CITY of NOVI CITY COUNCIL

Agenda Item 1
June 17, 2019

SUBJECT: Final approval of the request of Orville Properties, LLC for Final Approval of the First Amendment to the previously-approved Planned Rezoning Overlay (PRO) Plan and Agreement, JZ18-24, Adell Center PRO. The subject property is approximately 23 acres and is located on Expo Center Drive (now Adell Center Drive), north of Grand River Avenue and south of I-96 in Section 15. The applicant seeks to revise the PRO Agreement to amend the approved layout for Units 6 and 7, common landscape areas, building signage, and location of accessory units.

**FIRST AMENDMENT TO
PLANNED REZONING OVERLAY (PRO) AGREEMENT
ADELL CENTER**

P.R.O. PLAN (OVERALL)

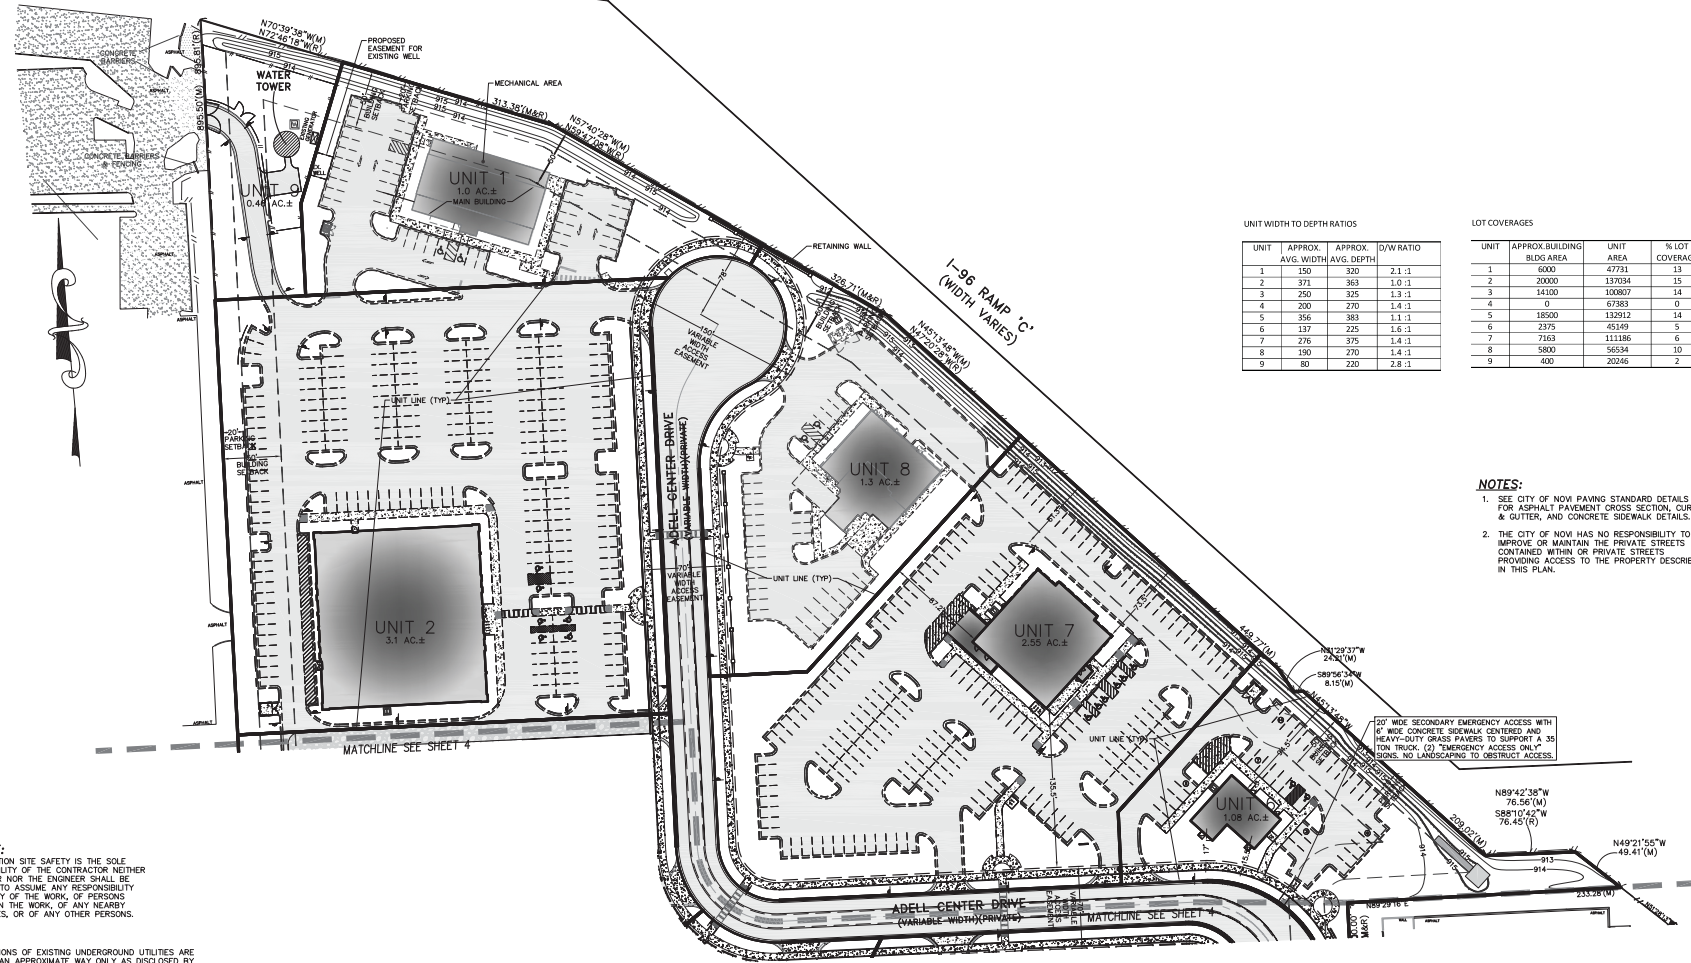
1. The PRO Plan referred to on Page 1, Recitation T, and attached as **Exhibit B** to the PRO Agreement is hereby replaced with the PRO Plan attached hereto as **Exhibit B**. The following material changes are intended to be reflected in the revised PRO Plan:

- (i) Lot lines are different from the original PRO Plan.
- (ii) Lot acreage for Unit 7 is increased from 1.5 acres to 2.55 acres. Unit 6 is correspondingly smaller.
- (iii) Shared parking between Units 6 and 7 is no longer proposed.
- (iv) The western entry drive from Adell Drive is relocated to the south.
- (v) Curb cuts along Adell Drive for Units 6, 7 and 5 are relocated.
- (vi) The building footprint for Unit 7 is revised.
- (vii) Minor changes to the parking layout of Unit 5 are included.
